COPY 2
CITY OF DURBAN
 PLAN NUMBER
 0862/02/91/3
 APPROVED SUBJECT TO
 FOLLOWING CONDITIONS:
garage door not to exceed over boundary
 APPROVED: **D.C. MACLEOD**
 CITY ENGINEER
 DATE 20 MAY 1991

OWNERS SIGNATURE *PMJ Simmons*
 RATE No. 0367 5006
 PROPOSED 2nd GARAGE, POOL EQUIPMENT & FURNITURE STORE ROOM, BOUNDARY & SCREEN WALLS.
 for: MR. PMJ SIMMONS
 of: 161 HOLLANDZEE CEREC. DURBAN
 of: LOT 518 DURBAN

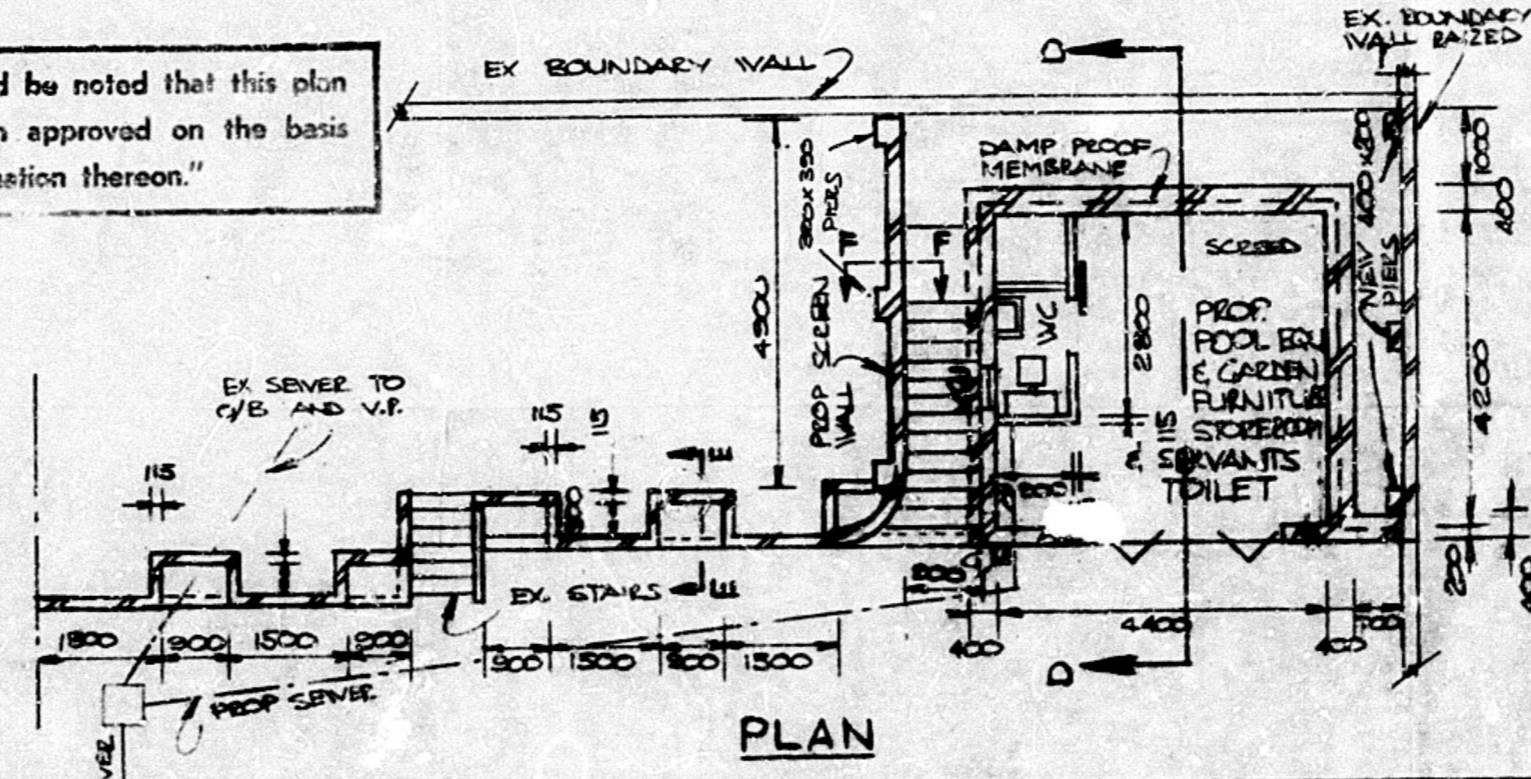
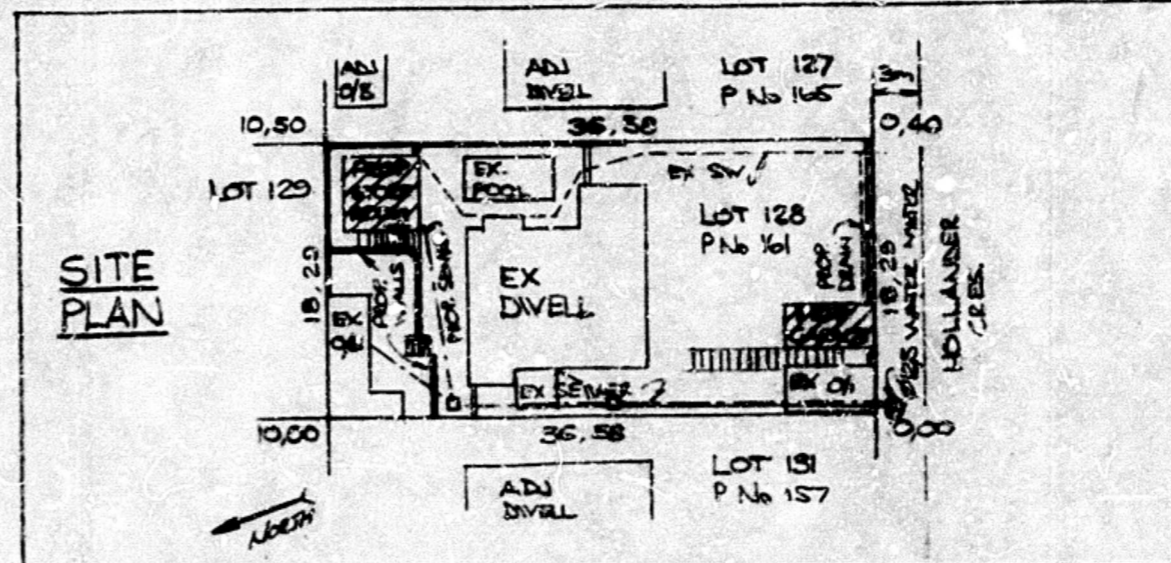
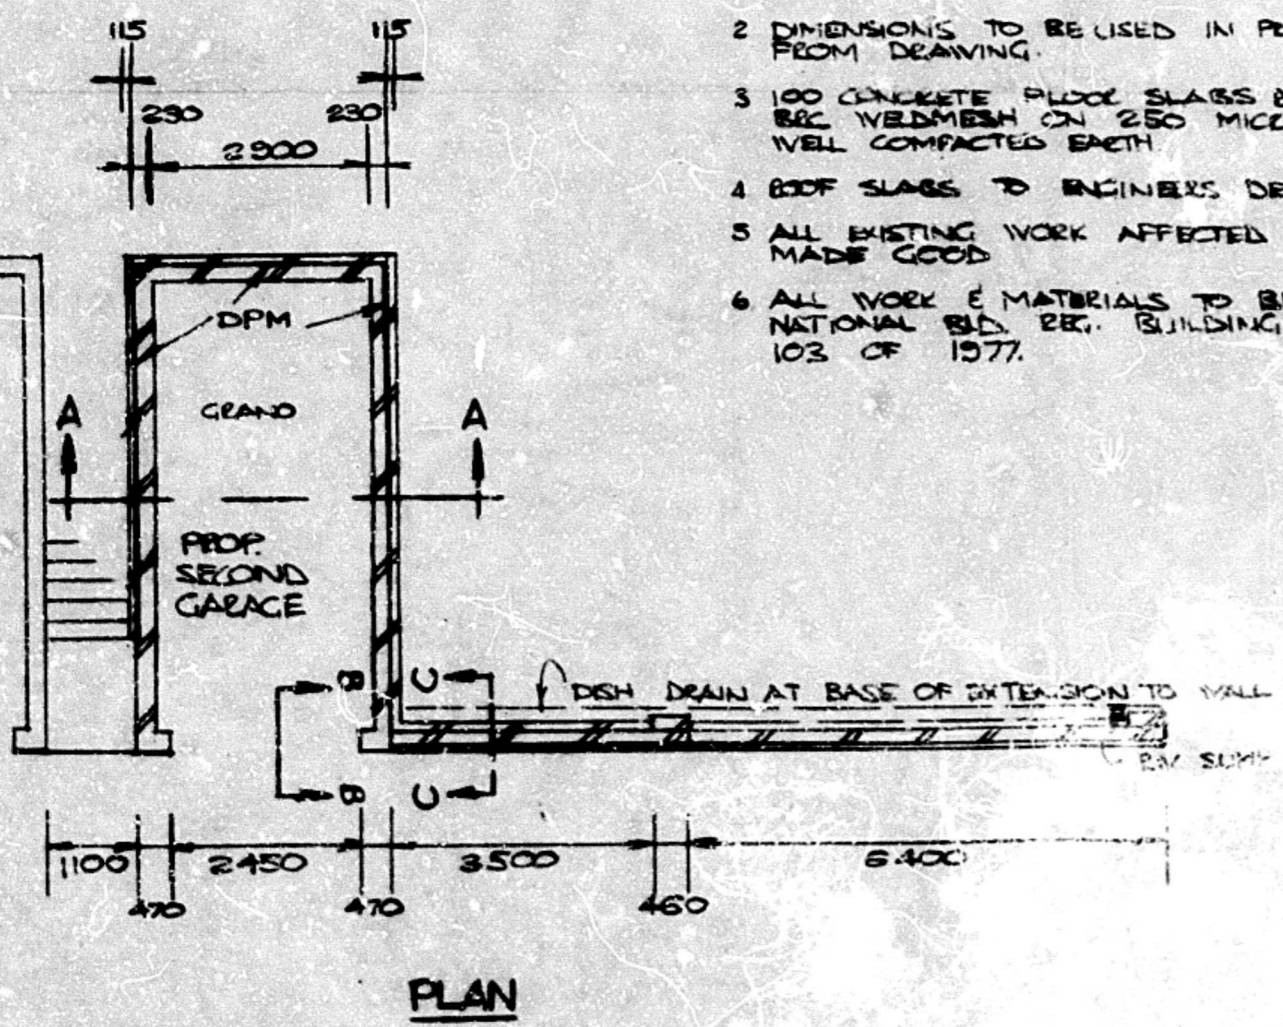
ENGINEER'S DETAILS OF RETAINING WALL REQUIRED
 R/C DETAILS REQUIRED
